REFERENCE LHC-EQCOD-EC-XXXX

ENGINEERING CHANGE REQUEST

Installation in IR7 of dispersion suppressor collimators (TCLD)

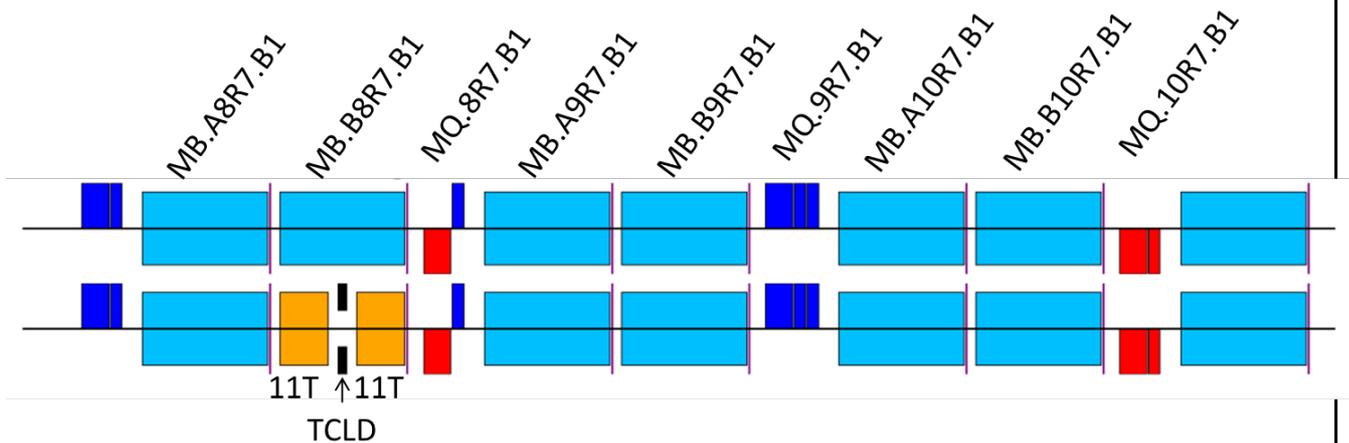
Simulations and present knowledge of the quench limits of the standard dipoles as well as the 11 T magnets have shown that the preferred placement of the TCLD is in cell 8 (on the right side of IR7 for B1 and left side for B2) [7]. The standard dipoles to be replaced by the assembly of two 11T magnets are MB.B8R7 and MB.B8L7. The schematic layouts of the present and post-LS2 IR7 dispersion suppressor on the left side of IR7 are shown in Figure 1.

Figure 2 - Positions of new TCLD collimators in IR7. Figure taken from Ref. [12].

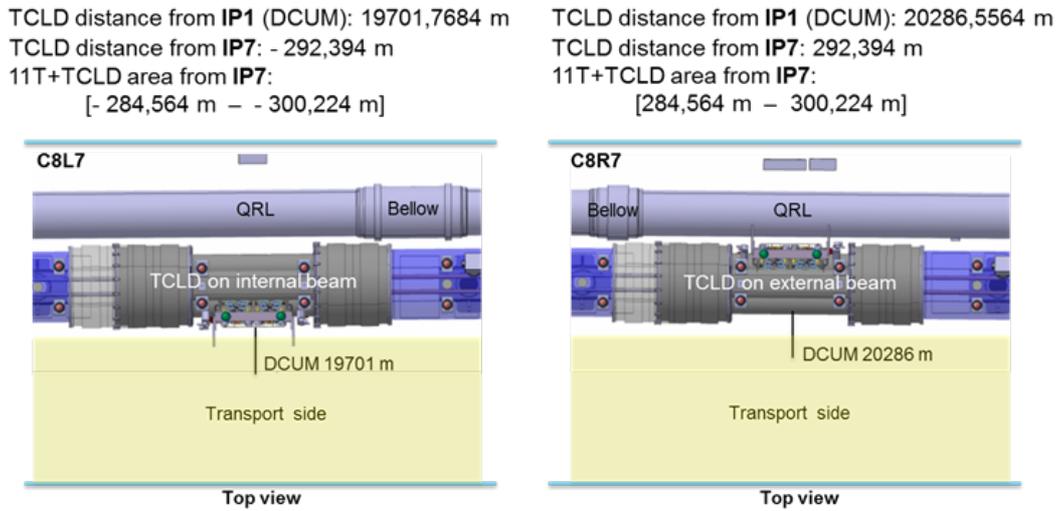
The integration and positions of the two TCLDs are shown in the drawings in Figure 2. More details on the integration are presented in Ref. [12].

Figure 3 – Drawing of one of the TCLD jaws (top), including RF fingers, cooling pipes and BPMs, and the two jaws installed on the table (bottom). Courtesy of L. Gentini.

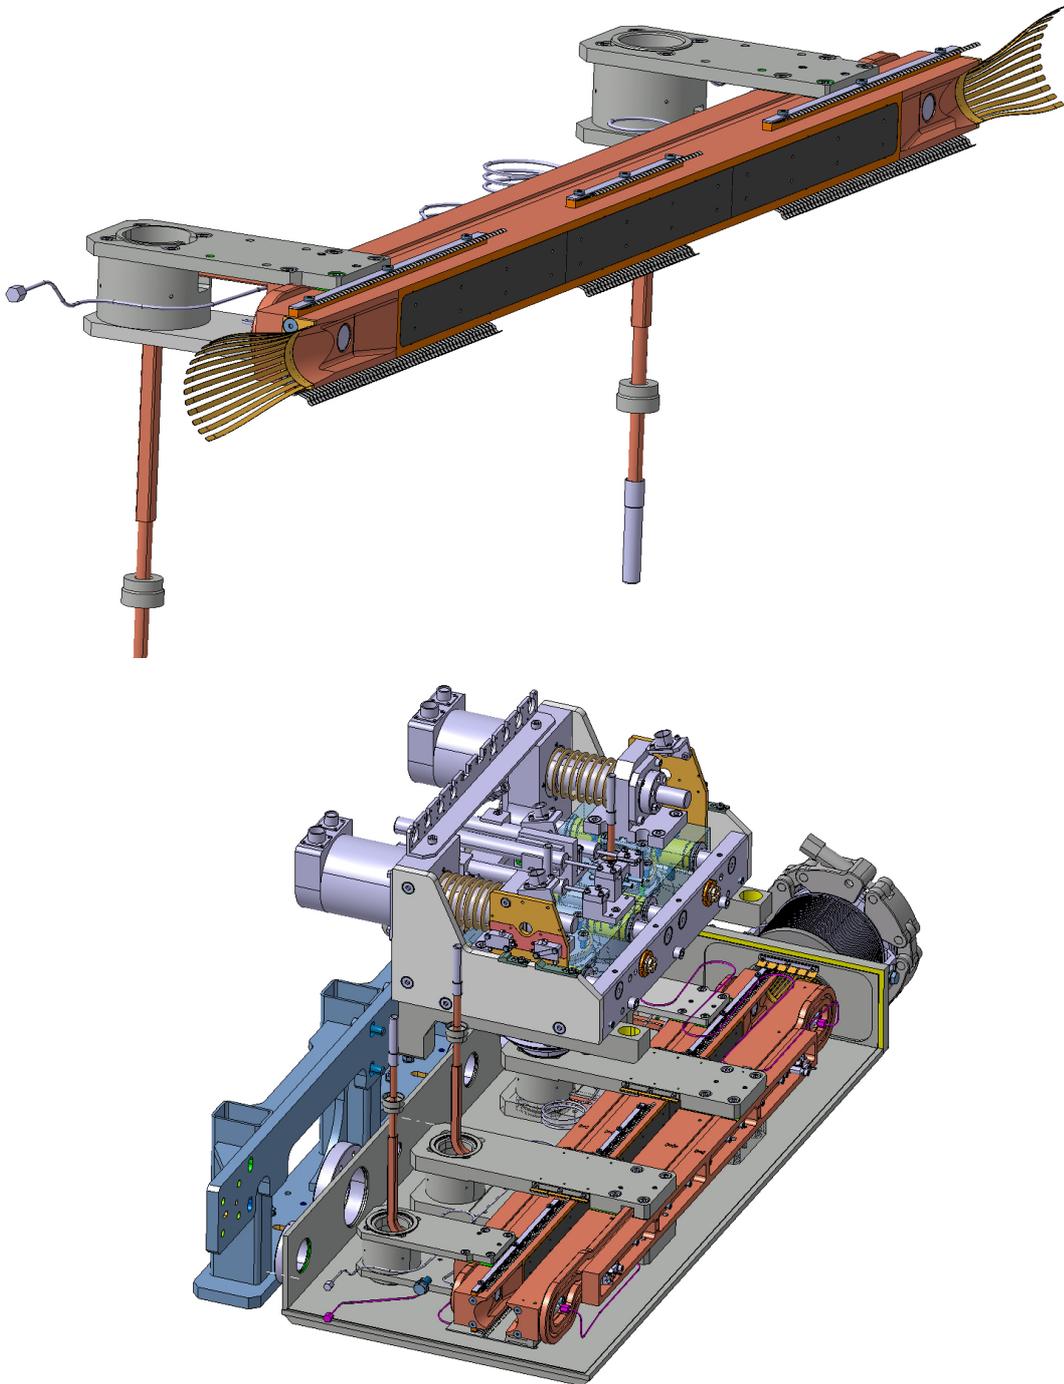
The TCLD consists, as most other LHC collimators, of two parallel jaws collimating the beam in the horizontal plane, with the beam passing in between them. The active material of the jaws is the tungsten alloy Inermet 180. The design of the TCLD collimator, shown in more detail in Figure 3 and Figure 4, is derived from the design of the present LHC collimators, but with some differences. Because of the very tight space requirements, the design is challenging and the active length of the material had to be reduced to only 60 cm, in order to make it fit. This means that also a non-standard support design is used. The shorter length has only a minor adverse effect on the downstream energy deposition [10,11]. Furthermore, the bellows at the two longitudinal extremities are integrated in the tank transitions in order to gain longitudinal space. A 3D drawing of the tank and support is shown in Figure 5.

As all recent collimators, the design includes two BPM buttons per jaw, integrated at the extremities outside of the tapering. The jaws feature water cooling, using squared 9 mm pipes. Each jaw contains also 3 LVDT position sensors and 2 TP100 temperature sensors.

Figure 6 – The assembly to be installed between the two 11T dipoles, consisting of TCLD collimator, support, beam pipe for the other beam, and cryo-bypass. Courtesy of L. Gentini.

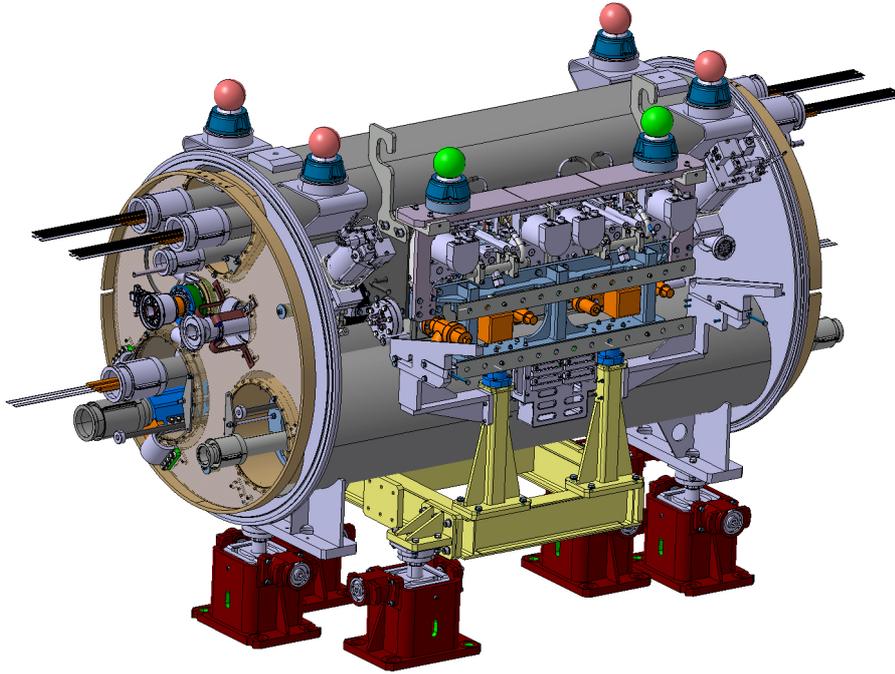
The TCLD will be integrated in a specially designed assembly, containing a beam pipe for the other beam, as well as a cryo-bypass, which is needed since the TCLD is a warm element placed between two cold ones. This assembly is shown in Figure 6 and the full installation including the two 11T dipoles is shown in Figure 7.
